Project	<b>IEEE 802.16 Broadband Wireless Access Working Group</b> < <a href="http://ieee802.org/16">http://ieee802.org/16</a> >	
Title	<b>QoS Management Subheader for Facilitation of Uplink Scheduling</b>	
Date Submitted	<b>2004-06-25</b>	
Source(s)	<p>Yongjoo Tcha, Yong-Bum Kim, Seong-Choon Lee  KT  17 Woomyeon-dong, Seocho-gu, Seoul, 137-792, Korea</p> <p>Jeong-Hwan Lee, Chung-Gu Kang  Korea University  1.5-ka, Anam-dong, Sungbuk-ku, Seoul, , 136-701, Korea</p>	<p>Voice : +82-2-526-6155  Fax : +82-2-526-5200  <a href="mailto:yjtcha@kt.co.kr">mailto: yjtcha@kt.co.kr</a></p> <p>Voice: +82-2-3290-3236  Fax: +82-2-3290-3691  <a href="mailto:cckgang@korea.ac.kr">mailto: cckgang@korea.ac.kr</a></p>
Re:	IEEE P802.16e/D3 Letter Ballot	
Abstract	This contribution introduces a new type of MAC subheader, which provides dynamic QoS parameters for uplink scheduling.	
Purpose	The document is contributed to support certain comment on IEEE P802.16e/D3 Letter Ballot.

# QoS Management Subheader for Facilitation of Uplink Scheduling

P 37. Figure 19—Generic MAC header format

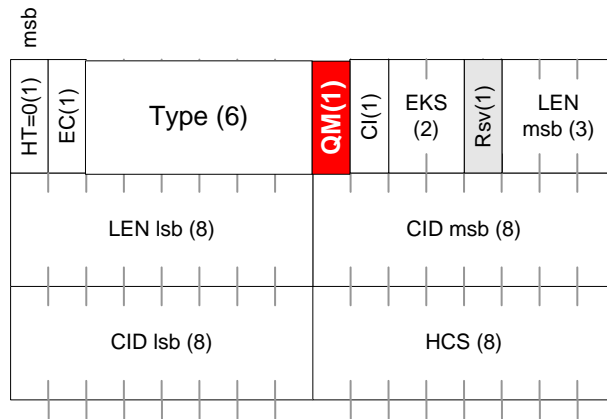
To support the uplink QoS parameters, a QoS management (QM) subheader is defined as an additional subheader. **One reserved bit that is now a QoS management bit can be used to** indicate the presence of the QM subheader. As the reserved bit is used, the existing format of MAC header is not subject to any change. If the QoS management bit is set, dynamic QoS Parameters shall be transported by a QoS management subheader. The format of the QoS Management subheader is specified in Table 14.

*[Change the figure 19 in "the baseline document Section 6.3.2.1.1 Generic MAC header in page 37."]*
